## DEVIATION REQUEST AND DECISION FORM

Project Name :	Crossroads North
Schedule No.(s) :	5408001008, 5408001029, 5408001032, 5408001033, 5408001034, 5408001041, 5408001042, 5408001050, 5408001051, 5408001052
Legal Description :	LOTS 12, 13, 14, 15, 16 AND 18, HILLCREST ACRES, ACCORDING TO THE PLAT THEREOF RECORDED MAY 12, 1960 AT RECEPTION NO. 153860, EXCEPT THAT PORTION ACQUIRED BY THE DEPARTMENT OF TRANSPORTATION, STATE OF COLORADO AS DESCRIBED IN RULE AND ORDER RECORDED APRIL 28, 2004 UNDER RECEPTION NO. 204068322, AND EXCEPT THOSE PORTIONS CONVEYED TO EL PASO COUNTY BY AND THROUGH THE BOARD OF COUNTY COMMISSIONERS OF EL PASO COUNTY, COLORADO BY SPECIAL WARRANTY DEED RECORDED DECEMBER 17, 2014 AT RECEPTION NO. 214116021 AND RECORDED DECEMBER 17, 2014 AT RECEPTION NO. 214116022, COUNTY OF EL PASO, STATE OF COLORADO. LOT 17, HILLCREST ACRES, COUNTY OF EL PASO, STATE OF COLORADO, EXCEPT THAT PORTION CONVEYED TO EL PASO COUNTY BY AND THROUGH THE BOARD OF COUNTY COMMISSIONERS OF EL PASO COUNTY, COLORADO BY SPECIAL WARRANTY DEED RECORDED DECEMBER 30, 2014 AT RECEPTION NO. 214119767. LOT 19, HILLCREST ACRES, COUNTY OF EL PASO, STATE OF COLORADO, AS AMENDED BY SURVEYOR'S STATEMENT RECO

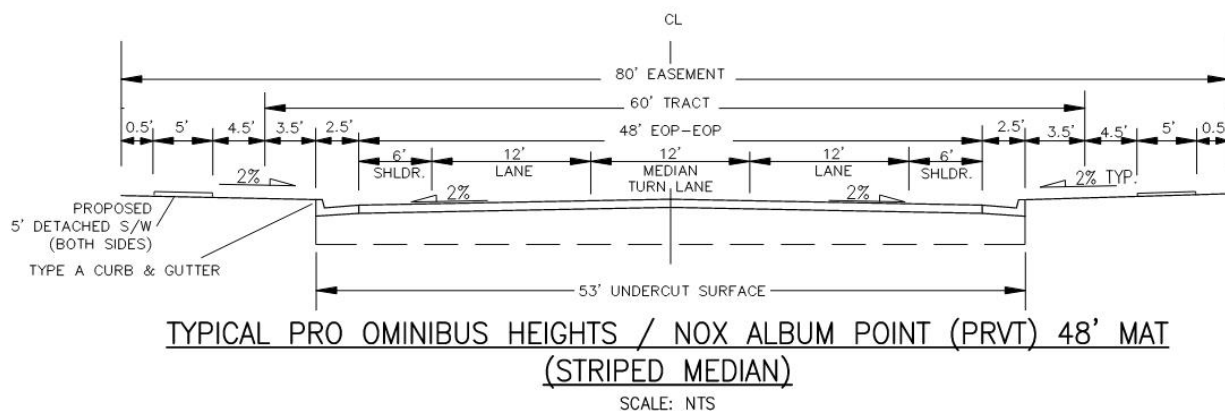
A deviation from the standard Urban Non-Residential Collector Roadway Cross Section for Pro Omnibus Heights and Nox Album View is requested. The standard cross section includes two travel lanes (12'), a striped median (12'), and two shoulders (6') within a 48-foot wide pavement mat; two 2.5-foot curb and gutter at the end of the pavement mat, two eight (8) foot (typical) landscape/tree lawns, two five (5) foot detached sidewalks all within an 80-foot ROW. A deviation from the minimum centerline radius for Urban Non-Residential Collector Roadways is also requested. The minimum radius is 565 feet.

The proposed private road cross section includes the following deviation(s) from standard ECM Standards for an urban residential collector section. Requesting for Pro Omnibus Heights and Nox Album Point;

- 60-foot Tract. Typical cross section is within an 80-foot easement.
- 48 foot pavement width, where typical cross section has a 48' pavement width. No Change

- Two 12-foot travel lanes, where typical cross section has two 12-foot travel lanes with two 6' shoulders. No Change
- Striped 12' median, whereas typical cross section has 12' striped median. No Change.

- 5-foot detached sidewalk, where typical cross section has 5' detached sidewalks, No Change.
- 200' minimum centerline radius (standard for urban local roadways) whereas typical cross section is 200' minimum centerline radius. No Change.

- Two 8' landscape/tree lawns. Typical cross section has two 8' landscape/tree lawns. No. change.
- 25 MPH design speed / 25 MPH posted speed (urban local), whereas typical cross section is 40/35 MPH.

- Typical cross section intersection spacing is 660' or 330' when intersecting local roadways. The layout of all of the commercial lots is not known at this time. Therefore, a deviation for the future applications will be necessary. Direct lot access allowance in conformance with ECM Section 2.4 is implied with this deviation for Lots 1-15. Each lot access will be reviewed with each application submitted.
